# Staff Report

To: Salt Lake City Planning Commission  
From: Casey Stewart; 801-535-6260  
Date: December 4, 2014  
Re: PLNSUB2014-00617 and -00618 Capitol Heights Planned Development / Preliminary Subdivision Plat

## PLANNED DEVELOPMENT / SUBDIVISION

**ATTACHMENT B: Site Plan**

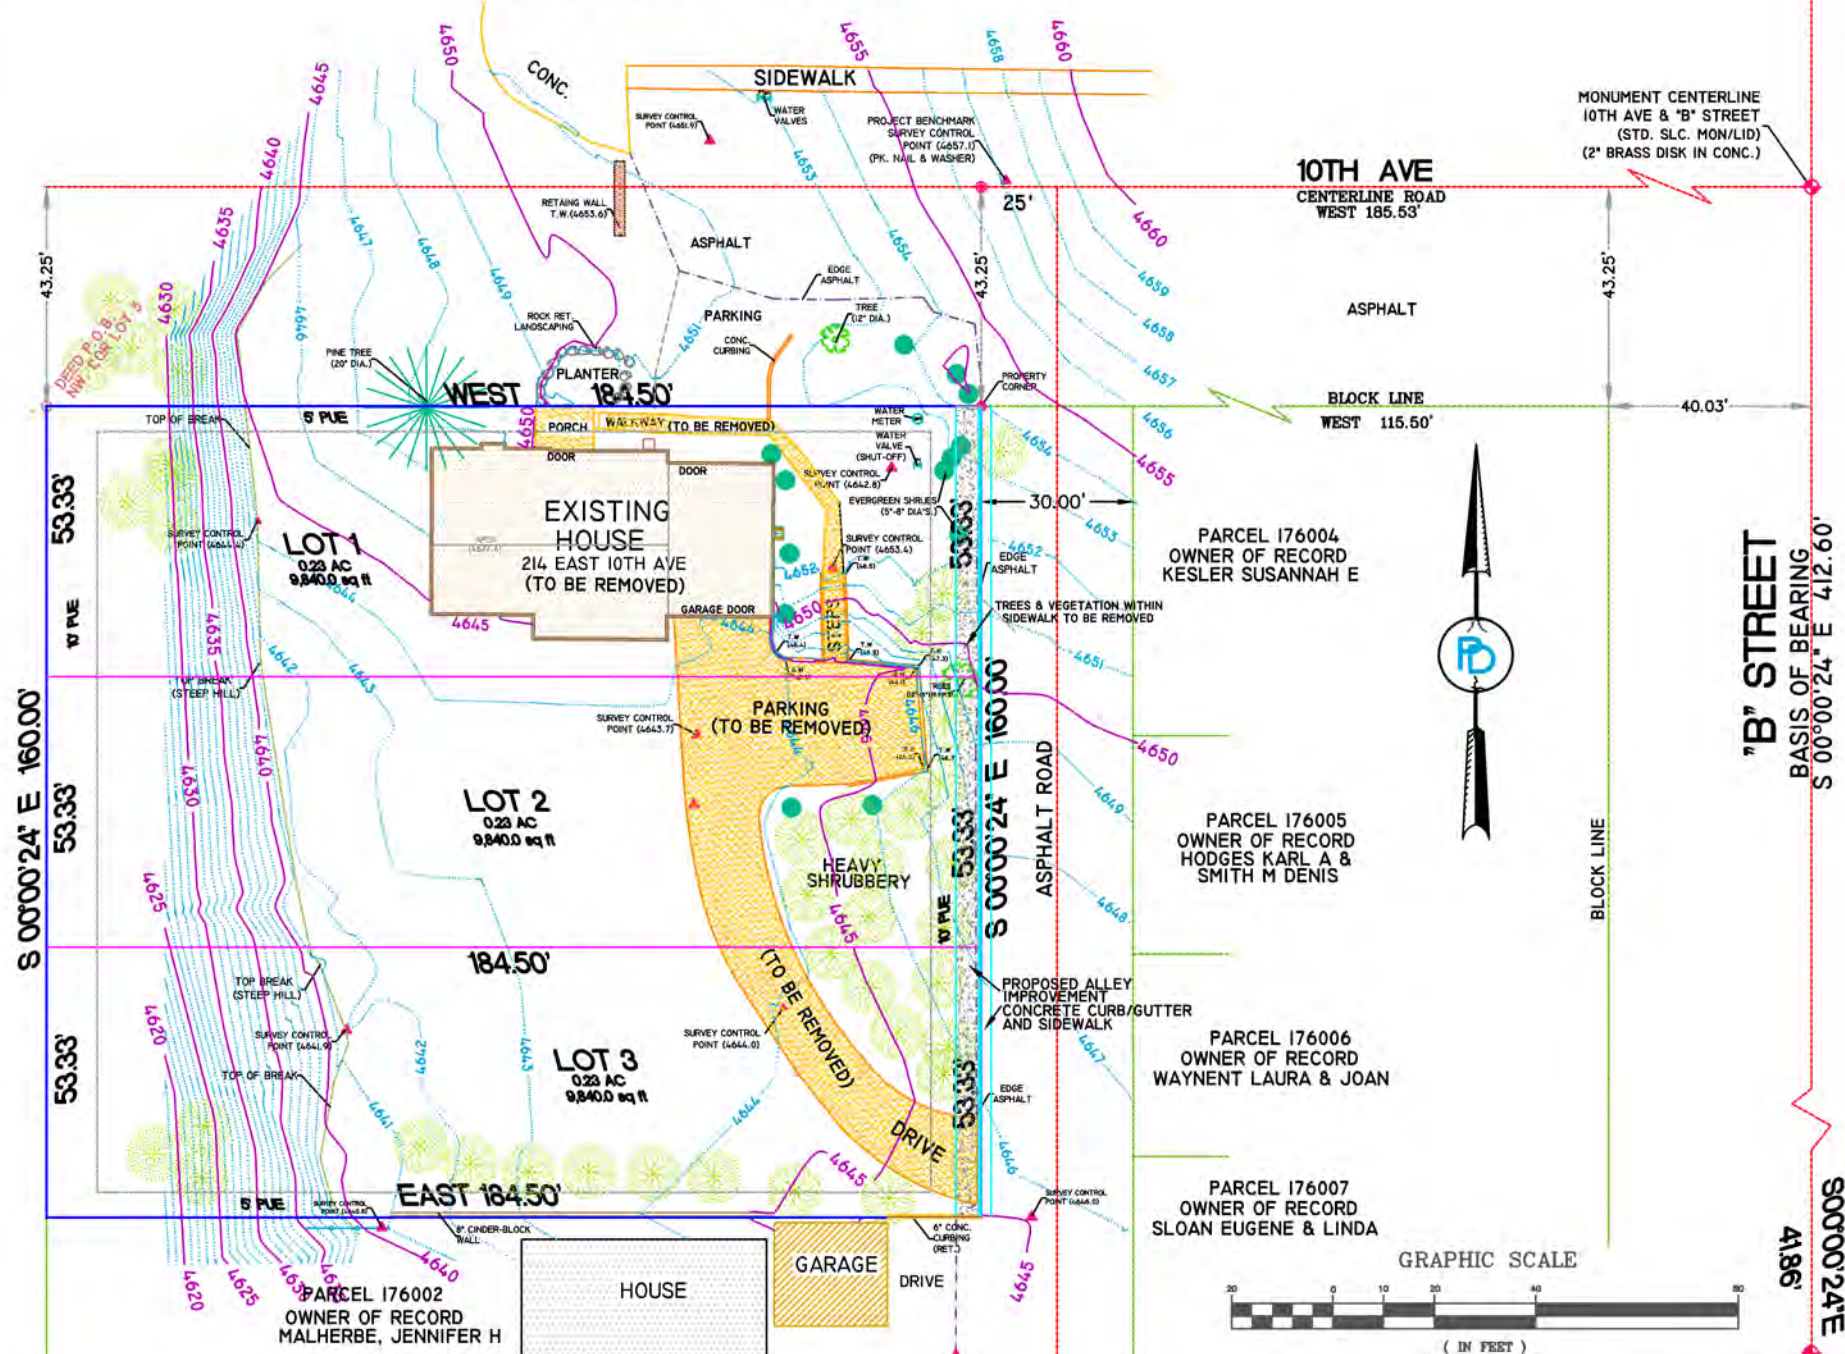
2. The submitted survey shows a western boundary for the property, which is unrealistic, as it is farther west than there is any actual land surface to build upon. The property drops down off a steep slope. The drawing proposal shows that the slope into the canyon commences before the boundary line. Thus, the calculation of lot size based on the figures given is NOT accurate, much less realistic.

1. The developer announces a five-foot sidewalk and the installation of curb & gutter but does not state or show on a plot plan where these “improvements” would be. The prior subject property owner already had encroached on the alleyway by five or six feet. This is the same line the developer’s survey drawing cites as the eastern boundary of the property. It is not the eastern boundary.

The submitted survey shows a western boundary for the property which is unrealistic, as it is farther west than there is any actual land. The drawing itself shows that the slope into the canyon commences before the boundary line. No calculation of lot size based on the figures given is realistic.

4. The developer must be required to submit an accurate surveyed drawing and to specify exactly where on the survey he will place said “improvements”.
5. “Improvements” need to be a commitment, not a promise to be rescinded later.

We ask the developer to submit a realistic survey drawing and to specify exactly where on the survey he will place his various improvements. We ask for a commitment, not a promise he can rescind later.

## **ATTACHMENT C: Building Elevations**

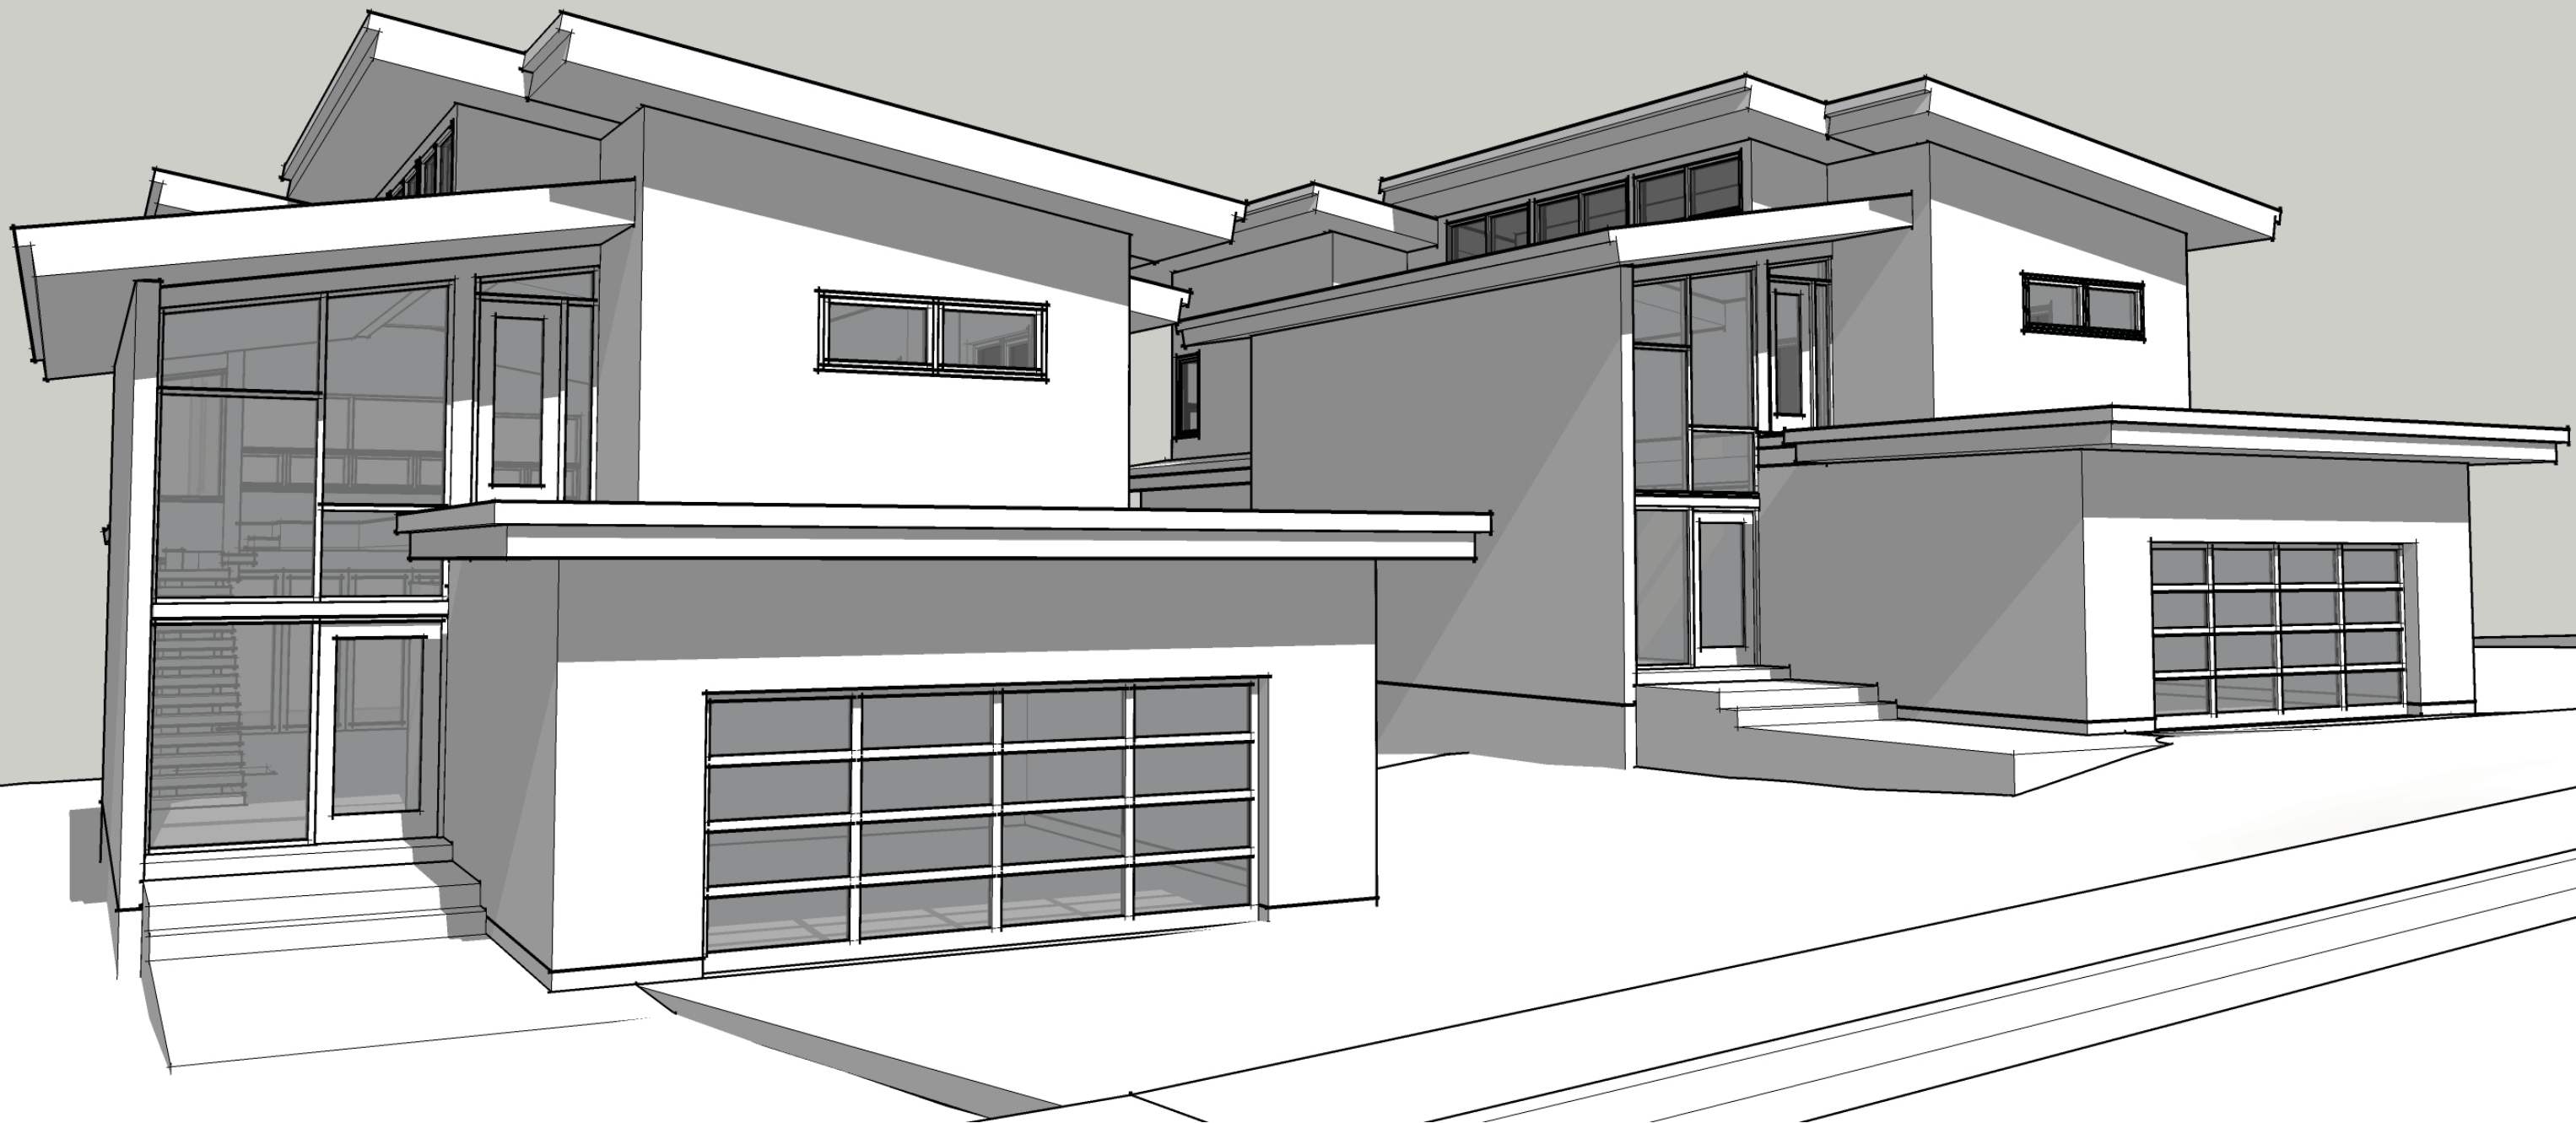
The proposal included rough sketches of the new dwellings. The attached garage protrudes from the front of the building, obscuring the front entrance somewhat. The zoning ordinance requires the front façade to include the entrance door and other features such as windows, porches, etc. The door being setback from the garage may appear to some that the door is not part of the front façade. The planning commission should be aware that city staff have approved similar designs in the past and would consider this design as compliant, with the front façade comprised of both the garage and front entrance door and windows. No action is required, staff merely wanted to clarify any question about the design.
